Access Compliance Report

Public Rights-of-Way

(Curb Ramps)

Intersection ID: N/A	Main Street: MORABLIN_DR	Cross Street: ARLETA_CIR	Location: NW
ADA ID: 78FA819235B1	Ramp Type: PerpDiag	Initial Pass/Fail: Fail	Overall Compliance: No
Severity Score: 22.5			
Codes/Mitigation Info/Possible Solution		Field Measurements/Component Compliance

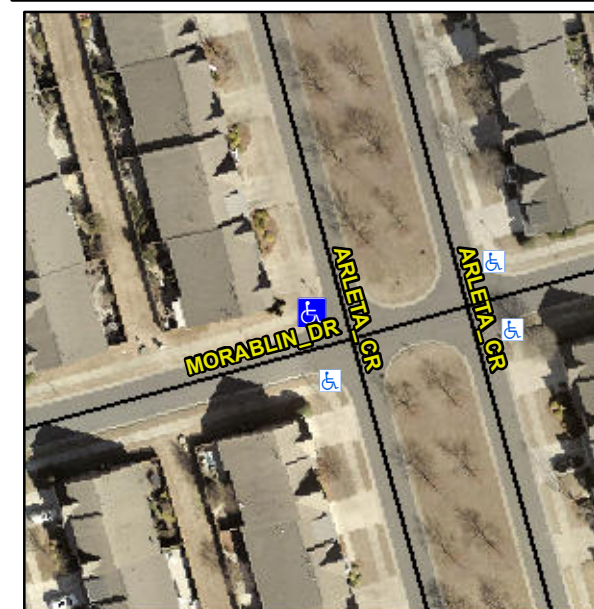
Not Found, R304.5.1, R304.2.2, R304.5.3

Compliance	Description	Data	Compliance	Description	Data
N/A	Ramp Length (in)	48.0	No	Ramp Slope (%)	8.7
No	Ramp Width (in)	39.0	No	Ramp XSlope (%)	2.7
N/A	Flare Type LT	N/A	N/A	Flare Type RT	N/A
N/A	Flare Slope LT (%)	N/A	N/A	Flare Slope RT (%)	N/A
N/A	Flare Traversable LT?	N/A	N/A	Flare Traversable RT?	N/A
N/A	Landing Length (in)	N/A	N/A	DWS Provided?	N/A
N/A	Landing Width (in)	N/A	N/A	DWS Contrast?	N/A
N/A	Landing Slope (%)	N/A	N/A	DWS Length (in)	N/A
N/A	Landing X Slope (%)	N/A	N/A	DWS Full Width?	N/A
N/A	Landing Curb? (Y/N)	N/A	N/A	DWS Offset (in)	N/A
N/A	Shared Landing?	N/A			
N/A	Gutter Ponding?	N/A	N/A	Gutter Slope (%)	N/A
N/A	Gutter Lip Ht (in)	N/A	N/A	Gutter X Slope (%)	N/A
N/A	Painted X Walk1?	No	N/A	Painted X Walk2?	No
	X Walk 1 Direction	To S		X Walk 2 Direction	To E
N/A	X Walk 1 Width (in)	N/A	N/A	X Walk 2 Width (in)	N/A
	X Walk 1 Slope (%)	2.6		X Walk 2 Slope (%)	1.5
	X Walk 1 X Slope (%)	0.5		X Walk 2 X Slope (%)	4.8

Remove & Replace Curb Ramp With Two New Directional Ramps or Equivalent.
